February 29, 2008

NATIONAL FIRE EQUIPMENT SYSTEM CACHE MEMORANDUM NO. 08-3

Subject: Kochek Hose Clamp Retrofit

Figure 1

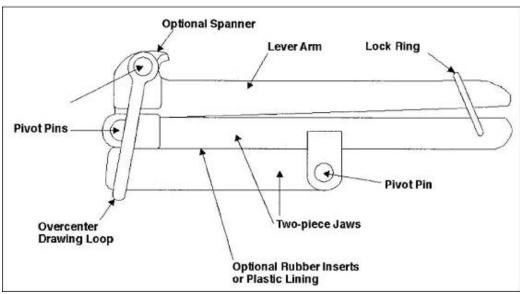
SDTDC investigated in detail the cause of the failure and explored possible retrofit options. The Kochek hose clamp is constructed with three pivot pins (see Figure 1). SDTDC found if pivot pin retention is not sufficient, the pivot pins hinging the two-piece jaws can be easily pushed out.

Most field failures are caused by the displacement of the pivot pin from the center arm of the two piece jaws. In the worst case scenario the pin completely separates from the assembly and the clamp falls apart. More often however, the displaced pin causes an impingement with the brass over-center drawing loop. When the handle is pushed down to shutoff water flow in the fire hose, the drawing loop presses against the pin causing the drawing loop to distort or break (see Figure 2)

Figure 4

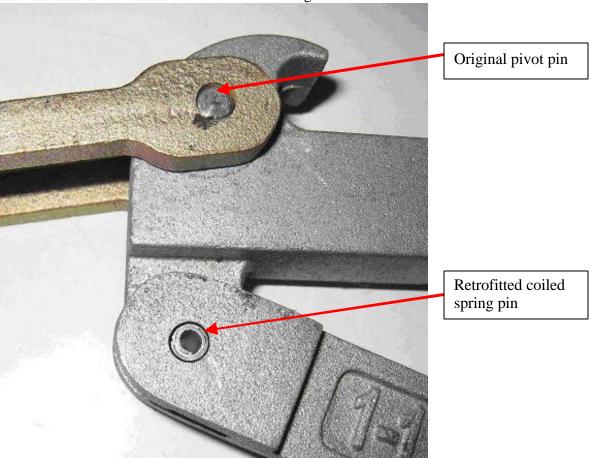
The most practical solution to correct this condition is to increase the pin retention, thereby eliminating the cause of failure. By substituting the two existing solid pivot pins (hinging the two-piece jaws) with coiled spring pins, pin retention is increased and standardized. Note: The third pin (to which the brass drawing loop is attached) has sufficient retention and does not require replacement (see Figure 3 and Figure 4).

- 1. Two (2) coiled spring pins shall replace the original solid pivot pins in the two-piece jaws.
 - a. The coiled spring pins shall be 0.25" nominal diameter and 0.75" in length.
 - b. The coiled spring pins shall be of stainless steel AISI302 / SAE 30302.
- 2. Press out the original solid pins in the two-piece jaws using an arbor press.
 - a. Pressing out original pins shall not damage the original pivot hole or cause excessive wear on the hole.
 - b. Note: the pivot pin attaching the brass over-center drawing loop to the casting is not to be replaced.
- 3. Using an arbor press, replacement pins shall be pressed in as to center the pin within the casting. There shall be no portion of the pin extruding past the outer surface of the casting.

Do not hammer out original pivot pins or hammer in new replacement coiled spring pins. This can cause excessive wear on the pivot hole and reduce pin retention.
